Inspection Report

Permit Number:	C0250005
Inspection Type:	PARTIAL
Inspection Date:	Wednesday, May 13, 2015
Start Date/Time:	5/13/2015 9:00:00 AM
End Date/Time:	5/13/2015 2:30:00 PM
Last Inspection:	Wednesday, April 29, 2015

Permittee: **ALTON COAL DEVELOPMENT LLC**
 Operator: **ALTON COAL DEVELOPMENT LLC**
 Site: **COAL HOLLOW**
 Address: **463 North 100 West, Suite 1, CEDAR CITY UT 84720**
 County: **KANE**
 Permit Type: **PERMANENT COAL PROGRAM**
 Permit Status: **ACTIVE**

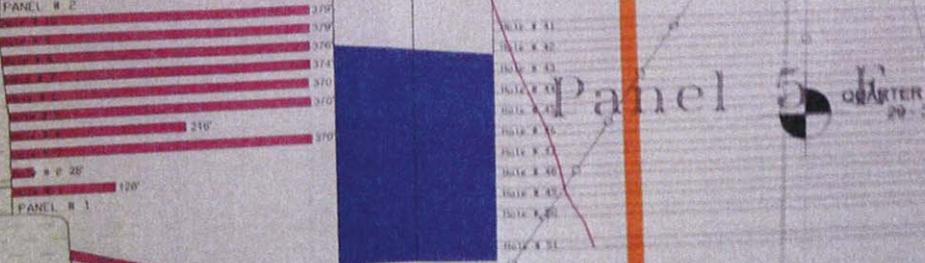
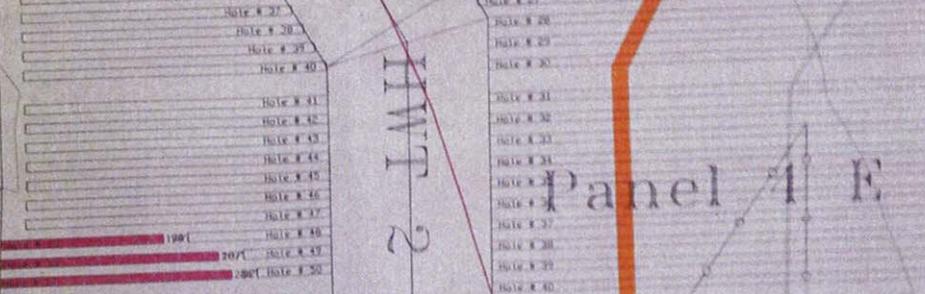
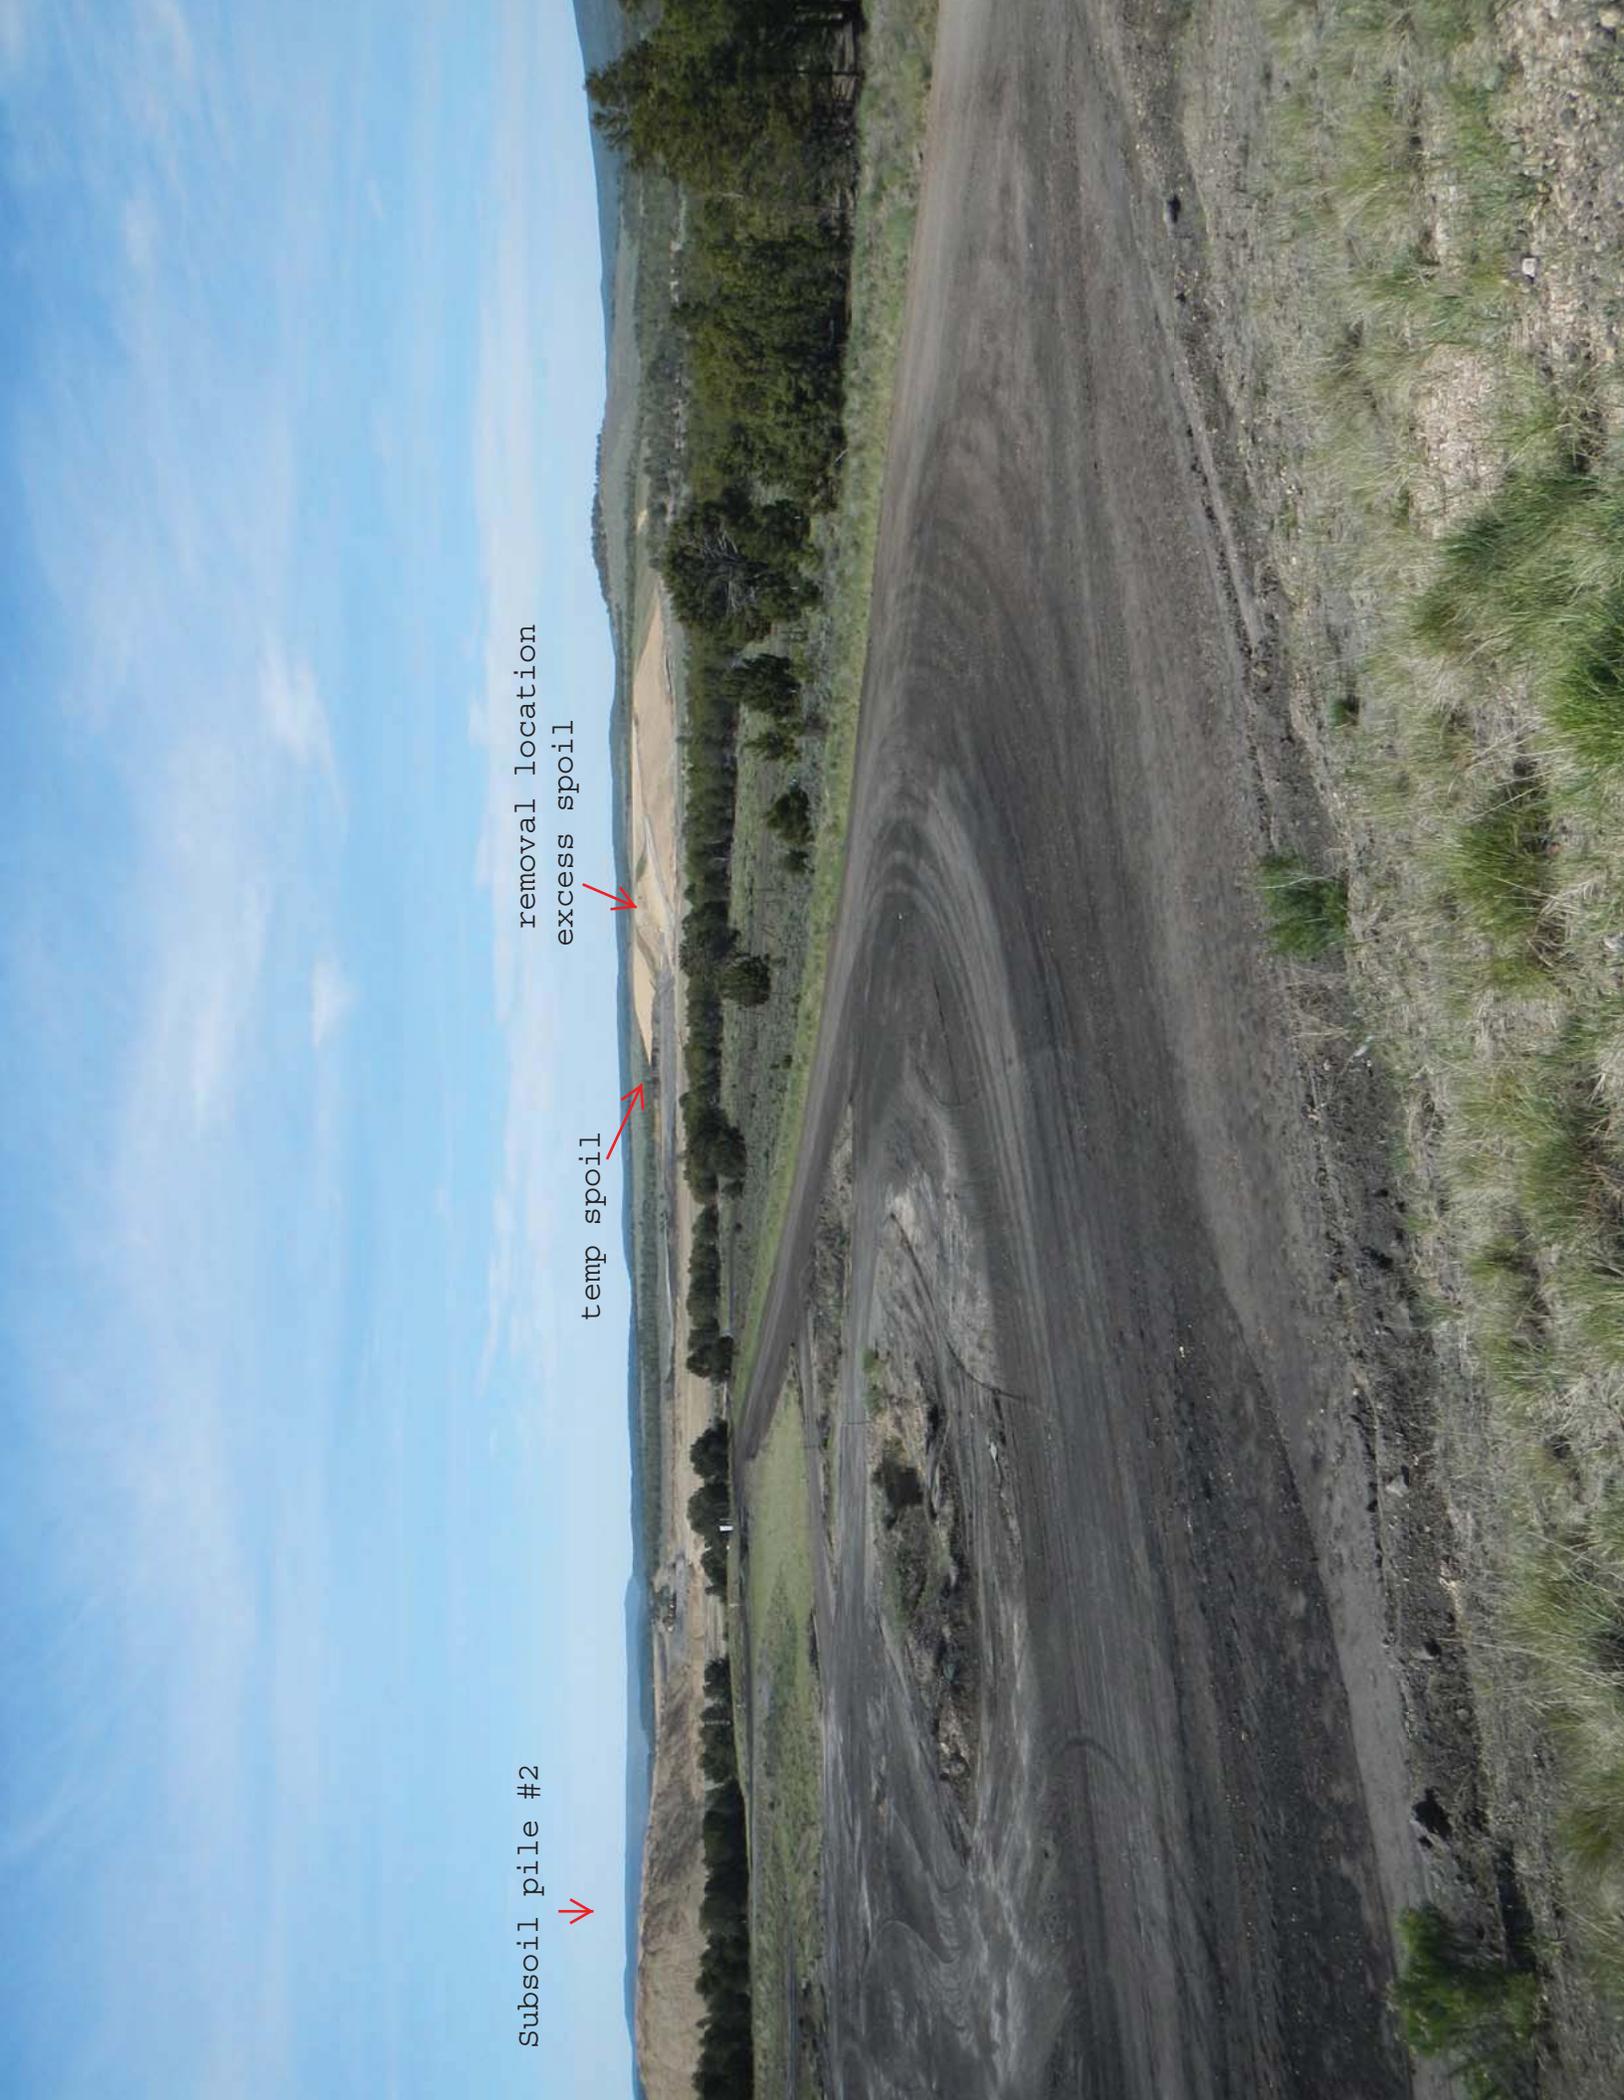
HWT 1 was backfilled above the coal. The haul road/entrance to the HWT 2 face was approximately 1,000 ft. long beginning in HWT 1. Mining activity was focused on construction and extension of HWT 2 where a blast was recently conducted and the overburden had been removed. (See the attached mining progress figure.) The alluvium above this section of HWT2 was being shaped to a 4h:1v slope. The coal in a 200 ft square block was being removed by an excavator and loaded onto haul trucks. This is the first coal to be loaded in a week. Mining activity also focused on construction and face-up of 3 portals in the UG Mine. Four coal haul trucks were running all day hauling gravel and cobbles from a gravel pit south of the mine on the County road to the UG mine/Pit 10 haul road. There was no backfilling occurring.
